PLANNING COMMISSION AGENDA REPORT

TO: St. Francis Planning Commission
FROM: Beth Richmond, Planner
SUBJECT: The Bluffs of Rum River
DATE: 8-10-2022 for 8-17-2022 meeting
APPLICANT: Landform Professional Services, LLC on behalf of SBD Properties, LLP
LOCATION: 23925 St Francis Blvd NW
COMP PLAN: Commercial, MDR, Open Space
ZONING: B-2 General Business, R-3 High Density Residential

The Buffs of Rum River Planned Unit Development and Preliminary Plat Application

PRELIMINARY PLAT
AUGUST 10, 2022

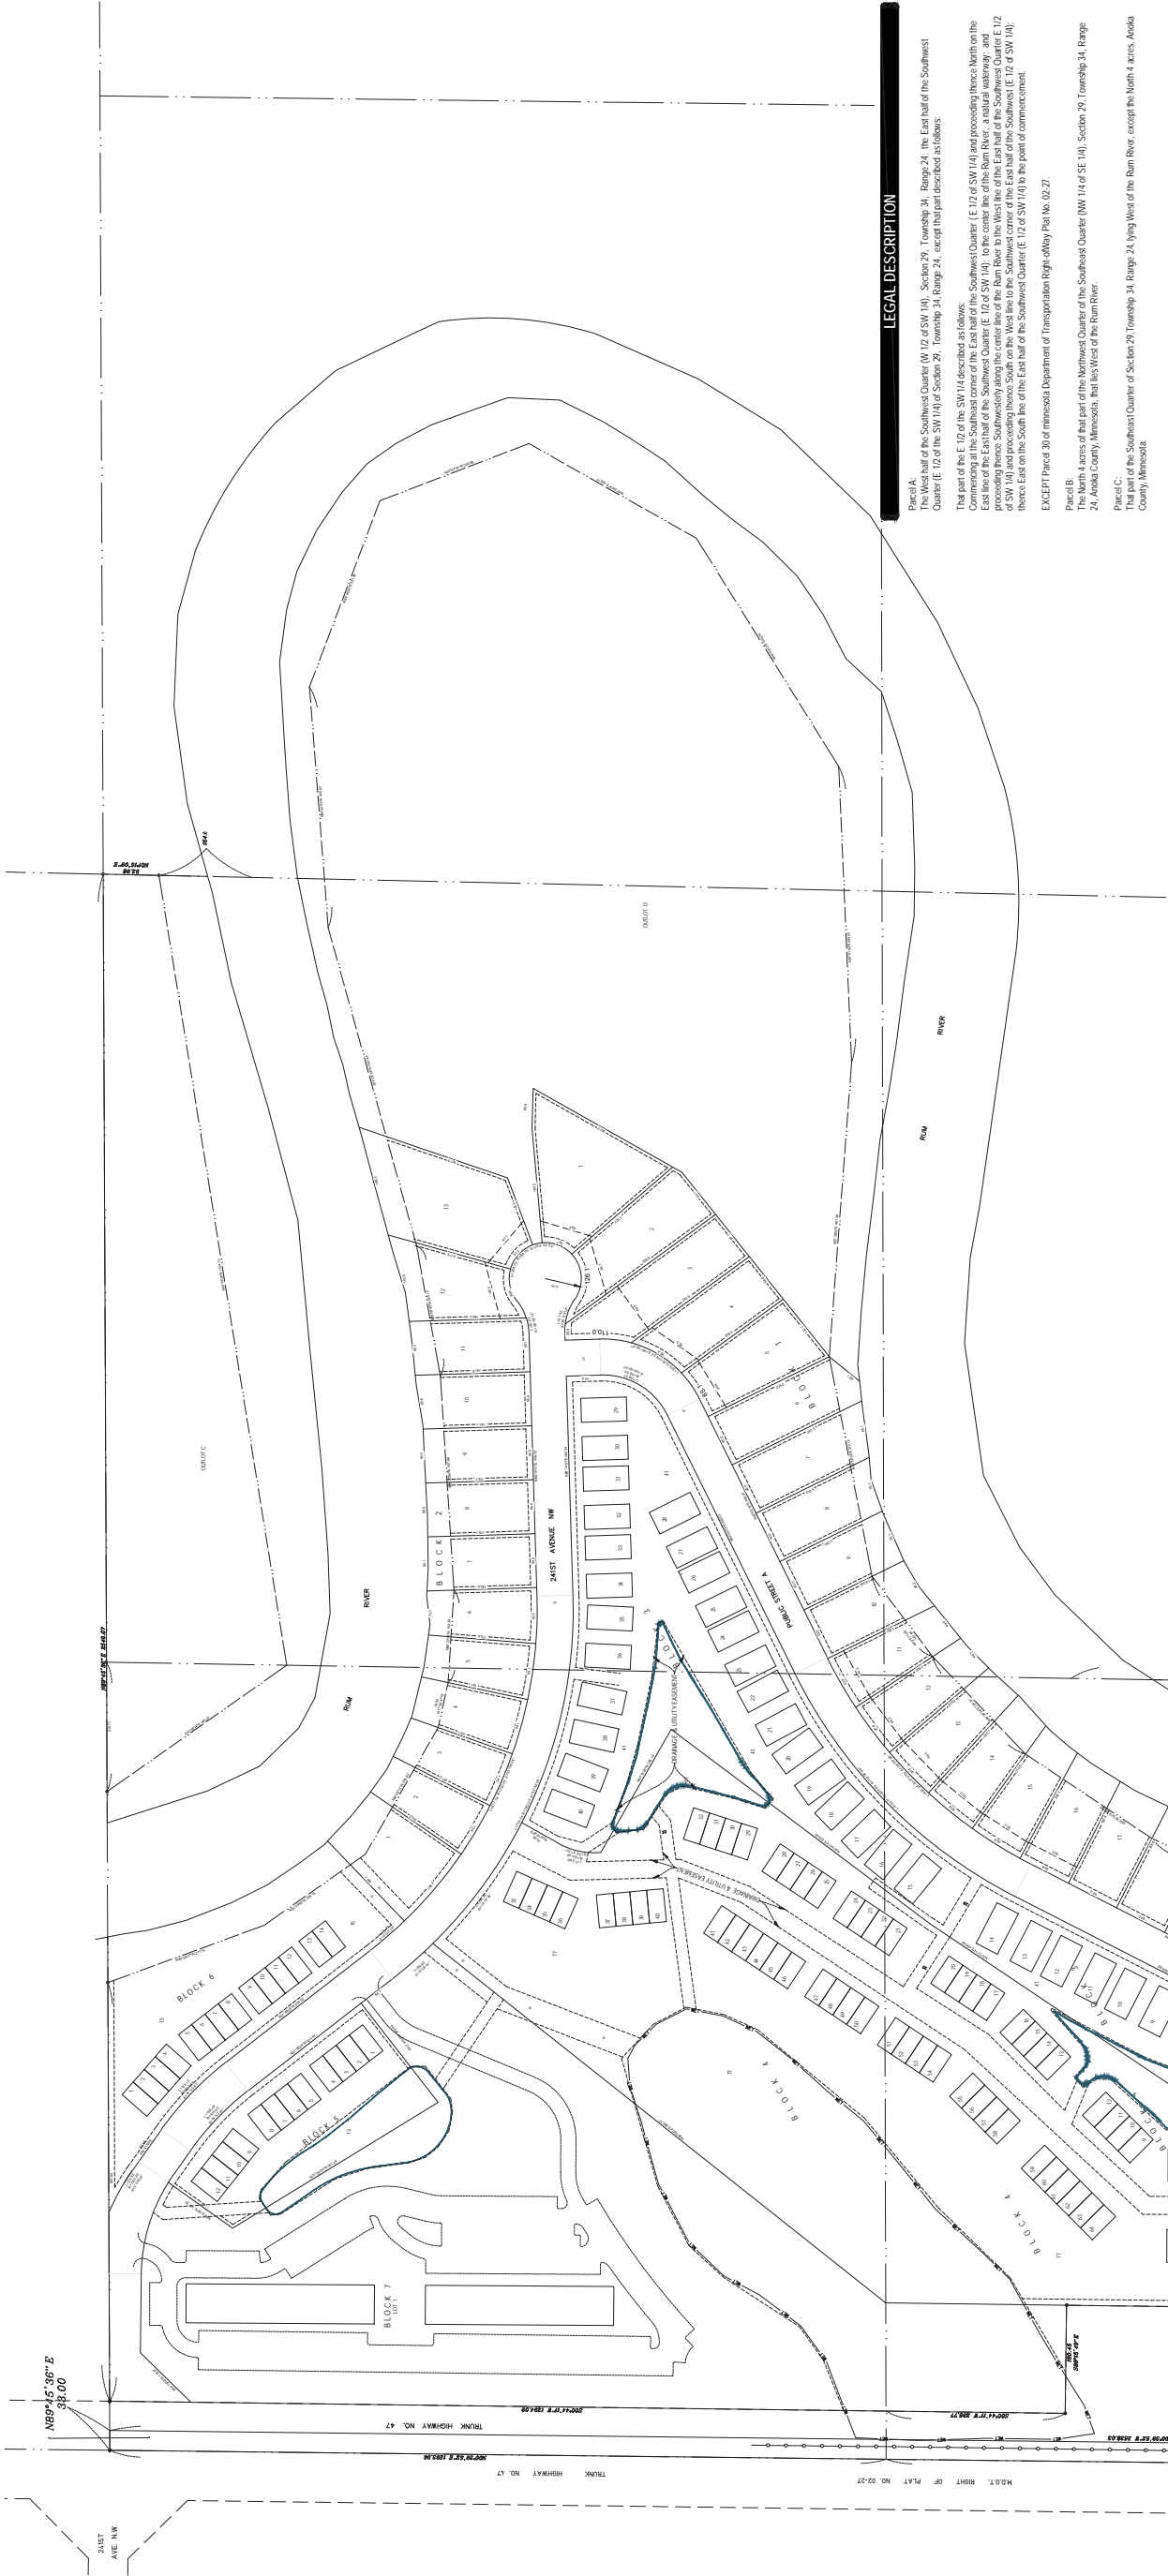
12. Applicant shall revise the preliminary plat to show all setback lines and building pads and to list all requested setbacks for each use type.
13. Applicant shall work with the Engineer to address any Engineering concerns or revisions listed in the Engineering Review Memo dated August 10, 2022.

3. The Preliminary Plans depict a cul-de-sac at 241st Avenue. Please revise to show a road connection to Highway 47.
4. The street layout as provided appears to be conducive with the property and provides adequate access to the proposed lots.

1. Based on the new traffic generated from this development, a connection to Highway 47 at 241st Avenue will be necessary. Please revise.
2. We recommend that a minimum drainage and utility easement width of 40 feet be provided to allow for the long term operation and maintenance of the public utilities within the private streets.
3. Drainage and utility easements at least 10' wide shall be provided on all lot lines. (11-44-01).
4. Additional easements may be necessary at access paths to stormwater basins. See Grading, Drainage and Erosion Control comment below.

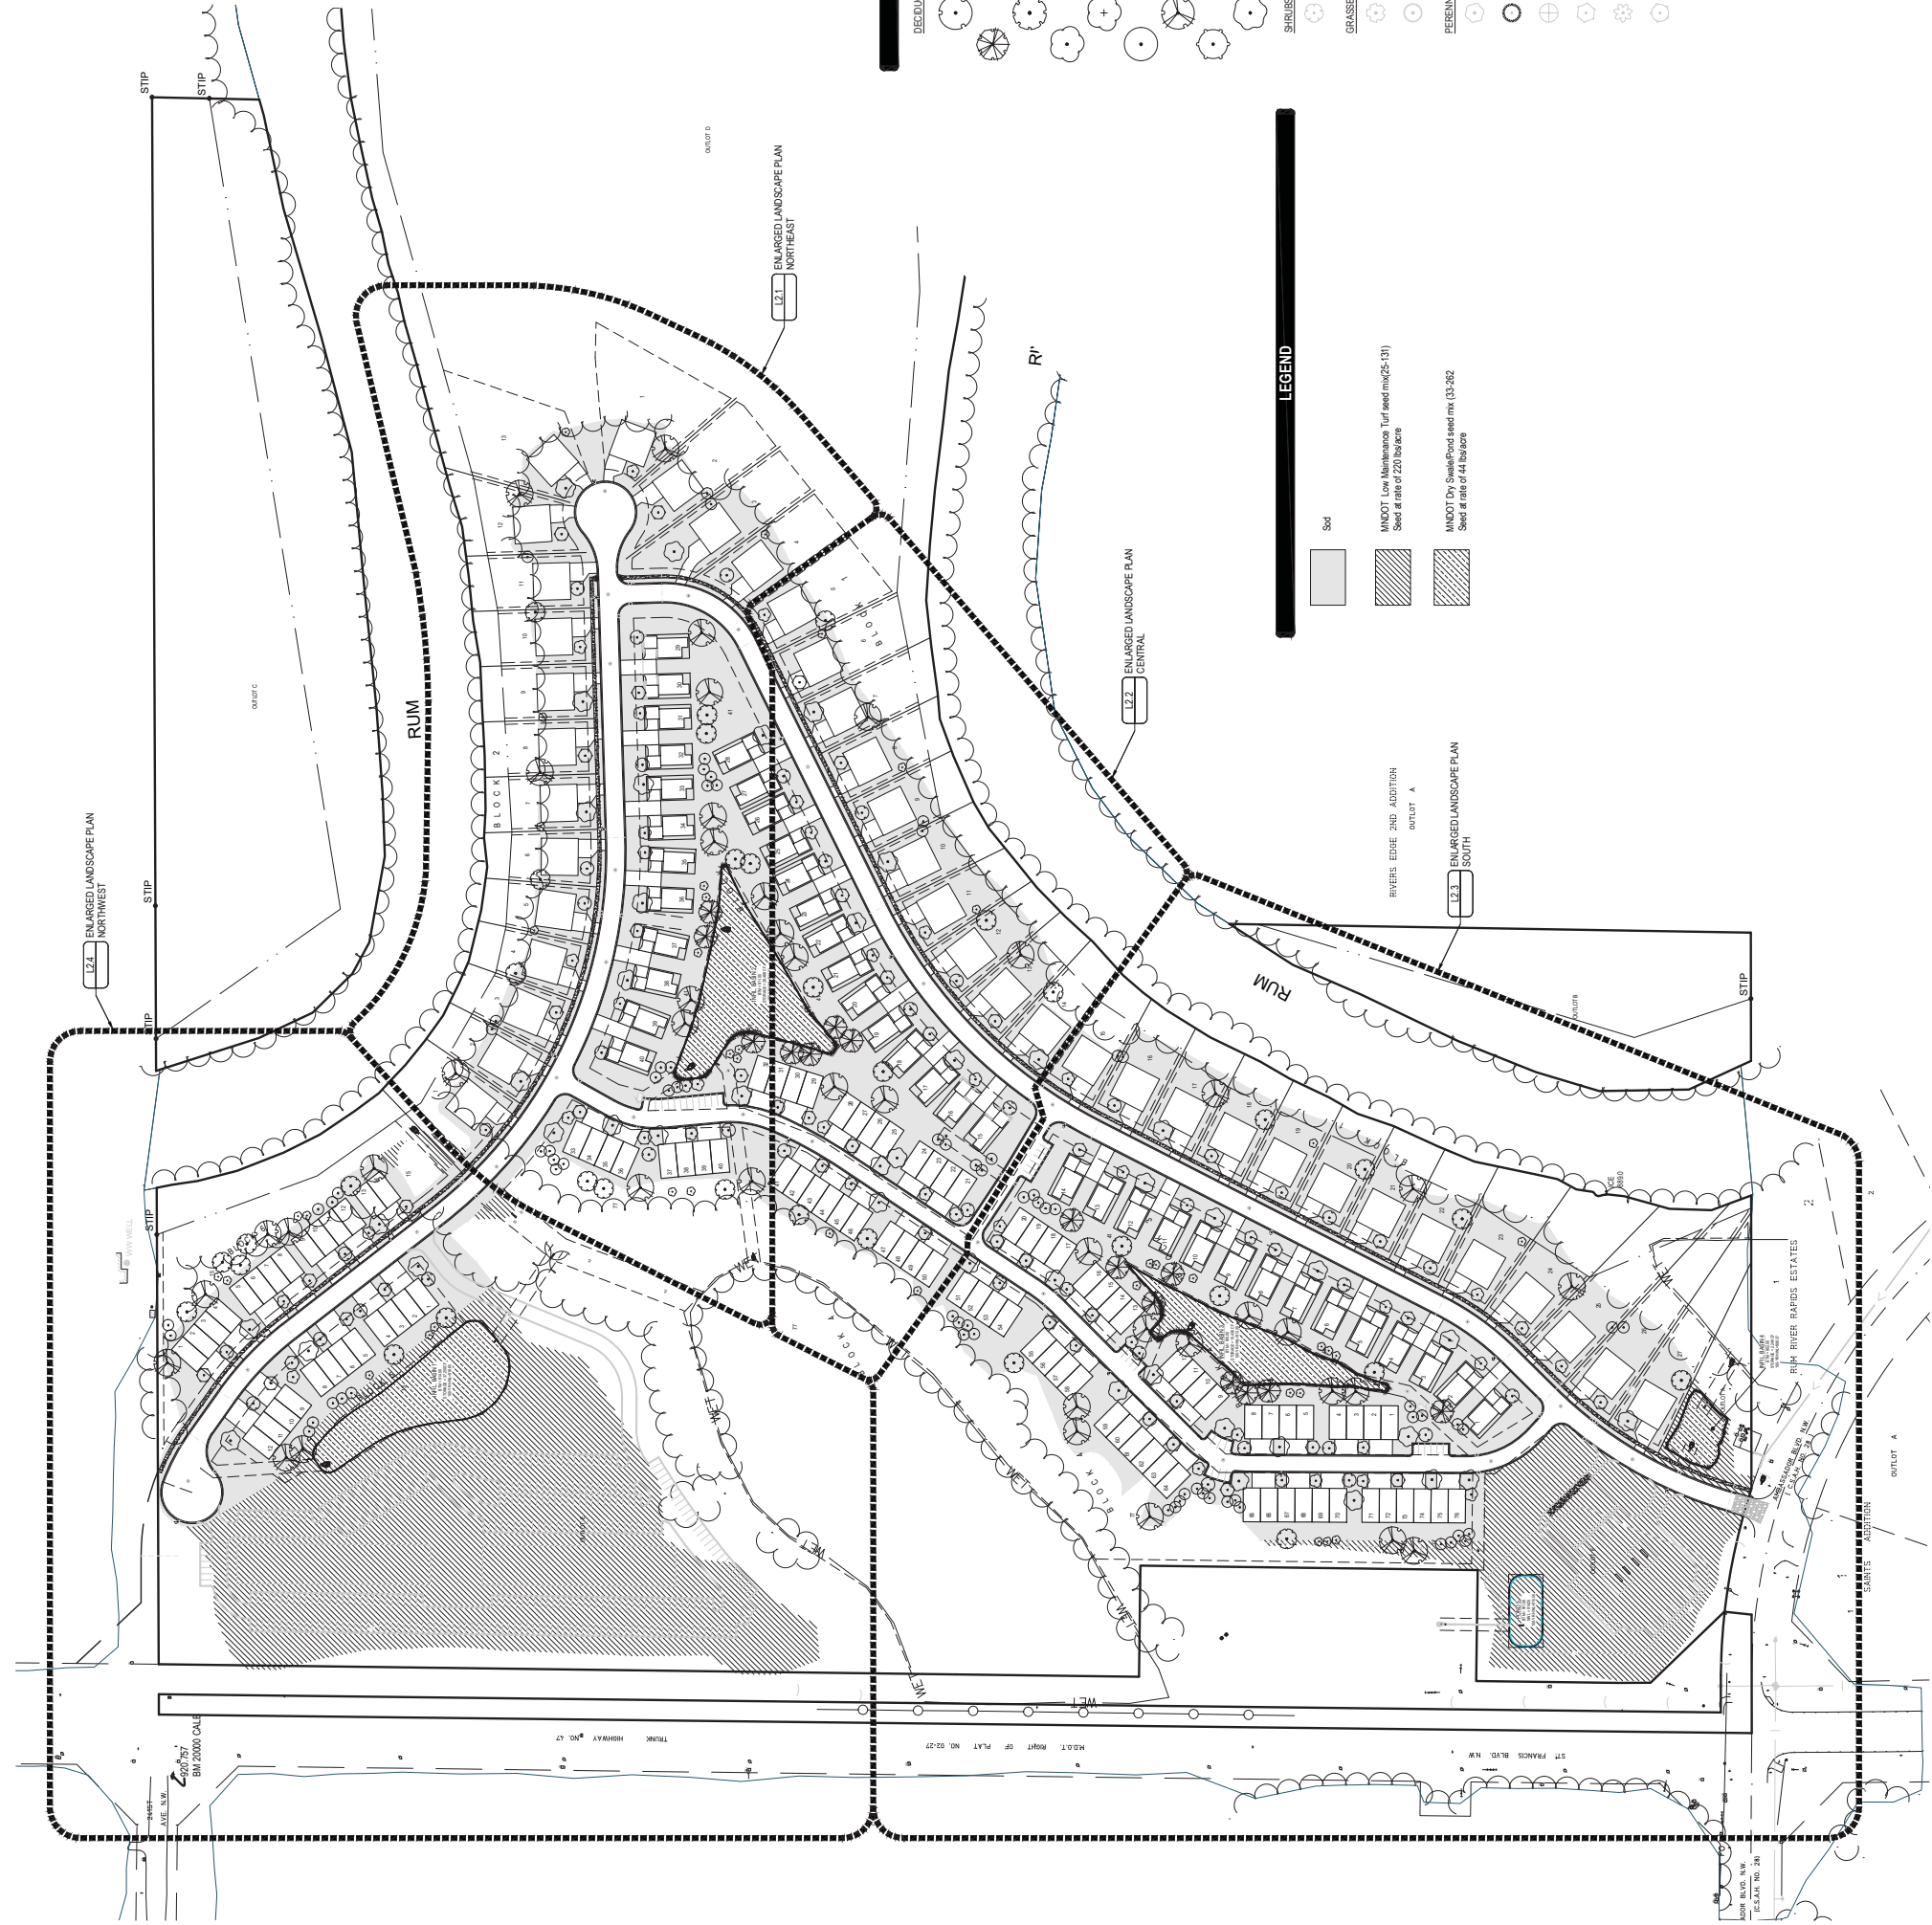
The applicant has provided a landscaping plan for the site. Existing trees which are planned to be removed or preserved should be shown on the plan.

Trees to be planted must be a mix of no less than 25% deciduous, 25% evergreen, and 10% ornamental. In addition, no genus may make up more than 25% of the full complement of trees. The applicant has met the genus requirement, but is only proposing deciduous trees. The applicant should revise the landscaping plan to meet the tree mix requirement. In addition, two of the tree types proposed, American Hophornbeam and Northern Catalpa, are not currently on the City’s list of acceptable trees. Based on Staff’s discussion with a landscape architect, these species are appropriate to be used as yard trees in the City.

11. Landscaping
 - a. Applicant should identify the size and type of existing trees which are planned to be removed or preserved.
 - b. Future landscaping plans for the apartment and commercial lots shall provide landscaping and vegetation which complements the landscaping established for the residential units in this plat.

- c. Trees to be planted must be a mix of no less than 25% deciduous, 25% evergreen, and 10% ornamental. Applicant shall revise the proposed tree mix to meet this requirement.
